SEQUOYAH NUCLEAR PLANT UNITS 1 AND 2 PIPE RESTRAINT STRUCTURAL STRAND TEMPERATURE 10 CFR 50.55(e) FINAL REPORT

CROSSOVER PIPES — PIPE WHIP RESTRAINTS

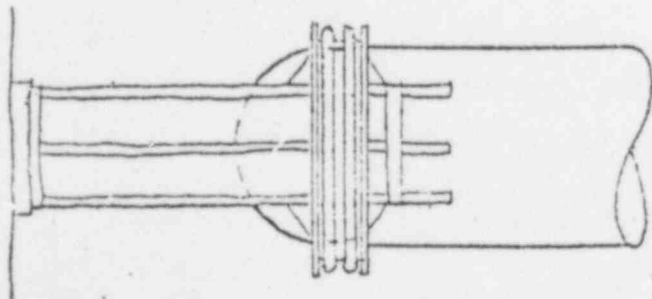
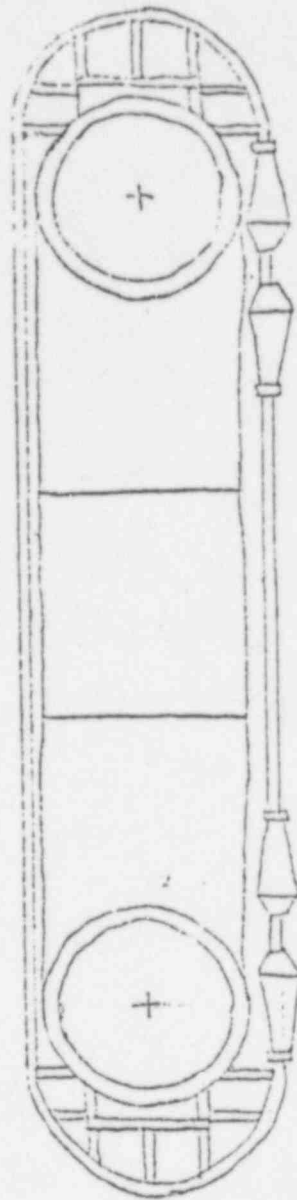
The pipe restraints involved are pipe whip restraints provided for the 37-inch O.D. crossover pipes between the reactor coolant pump and the steam generator in each Reactor Coolant System (RCS) loop. Each restraint (see attached sketch) consists of a pair of floor mounted pedestals, one under each pipe elbow at the ends of the relatively short run of horizontal pipe. The elbows point vertically upward. The pedestals are restrained from moving apart by two 2-7/8-inch structural strands which form loops around both pedestals. The pedestals are positioned such that the RCS piping, when hot, has a 1/8-inch gap with the upper strand (socket) on the outboard side; and when cold, has a similar gap on the inboard side. This configuration leaves a minimal space for thermal insulation between the strands and the pipe. The metallic insulation for each crossover leg was therefore designed to house both the pipe and the structural strands. This would result in the strands reaching a temperature near the RCS operating temperature. The strand material is carbon steel with a galvanized coating, which presented a problem since at the RCS operating temperature, the zinc galvanizing would diffuse into the steel, causing embrittlement. The strands, therefore, might fail under loss of coolant accident (LOCA) conditions.

Field measurements have been made during hot functional testing of the RCS, to verify the clearances between the piping and the structural strands, and to check the strand temperatures. At the time these measurements were made, there was not thermal insulation between the crossover pipe and the strands. At a

reactor coolant temperature of 547° F (design steam generator outlet temperature is 545.5° F), the highest strand temperatures were 235 to 250° F, with most temperatures in other strand areas being about 160° F.

The pipe thermal insulation is being redesigned to provide a horizontal V-notch configuration in the areas where the strands are in close proximity to the pipe. The insulation between the pipe and the strands will consist of a sheet metal baffle which will be sufficient in view of the temperature measurements made with no insulation, discussed above. The V-notch will permit natural circulation cooling of the strands by the ambient air. The corrective action will be completed before fuel loading for each of the plant units, respectively.
